APPLICATION NO.	FILING DATE	FIRST NAMED INVENTOR	ATTORNEY DOCKET NO.	CONFIRMATION NO.
10/619,891	07/15/2003	Vincent De Laforcade	NONY 3.0-004	7321
530	7590 08/17/2006		EXAMINER	
LERNER, DAVID, LITTENBERG, KRUMHOLZ & MENTLIK			DOAN, ROBYN KIEU	
	00 SOUTH AVENUE WEST		ART UNIT	PAPER NUMBER
WESTFIELD, NJ 07090			3732	
			DATE MAILED: 08/17/2006	5

Application No.	Applicant(s)			
Office Action Summary		10/619,891	DE LAFORCADE, VINCENT			
		Examiner	Art Unit			
		Robyn Doan	3732			
	The MAILING DATE of this communication appears on the cover sheet with the correspondence address Period for Reply					
A SHORTENED STATUTORY PERIOD FOR REPLY IS SET TO EXPIRE 3 MONTH(S) OR THIRTY (30) DAYS, WHICHEVER IS LONGER, FROM THE MAILING DATE OF THIS COMMUNICATION. - Extensions of time may be available under the provisions of 37 CFR 1.136(a). In no event, however, may a reply be timely filed after SIX (6) MONTHS from the mailing date of this communication. - If NO period for reply is specified above, the maximum statutory period will apply and will expire SIX (6) MONTHS from the mailing date of this communication. - Failure to reply within the set or extended period for reply will, by statute, cause

Affachment B

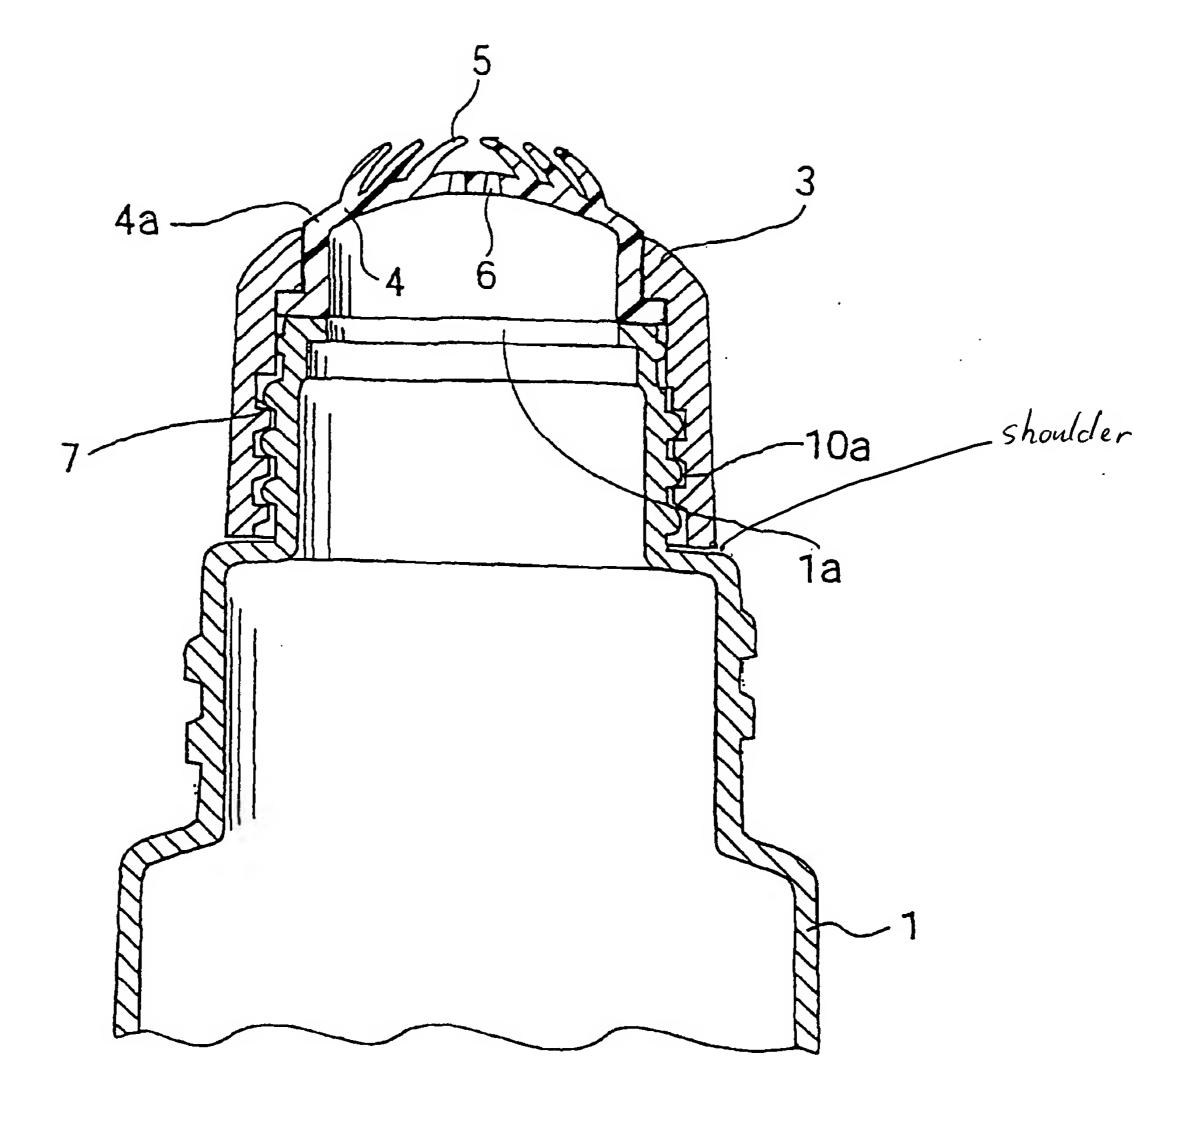
With regard to claims 48, 52 and 89, Ogino et al discloses a cosmetic receptacle (fig. 1) comprising a body (1) containing a cosmetic (col. 1, line 8), a neck (fig. 6 see attachment A) attached to the body, the neck comprising a first portion (see attachment A) having a first inside diameter (see fig. 6) and a first fixing means (10a) with thread, a second portion (see attachment A) located between the body and the first portion and having a second inside diameter (fig. 6) which is greater than the first diameter, the second portion further having a second fixing means (10) with thread, wherein the first and second threads inherently enabling screwing fastening in the same direction. In regard to claims 49, 50, Ogino et al shows the neck having a shoulder (see attachment B) with a plane annular surface extending outside the neck, the shoulder being perpendicular to the neck (see attachment B). In regard to claims 58 and 63, 77, Ogino et al discloses at least one accessory (3) having an applicator (4) configured for removably fixing onto the neck by fastening only on the fixing means. In regard to claims 64 and 69, Ogino et al shows the applicator having teeth (5, it is noted that filaments 5 are considered as teeth) and the applicator also having a row of teeth (fig. 2) which includes a pair of end teeth, the end teeth having no dispenser orifices. In regard to claim 76, Ogino et al shows the applicator being made by molding (col. 7, lines 62-67). In regard to claims 79, 80, 81-84 and 91-95, Ogino et al discloses at least two accessories (2, 3), a first one including a cap (2) and a second one including an applicator (3) and wherein the two accessories each incorporating with the first and
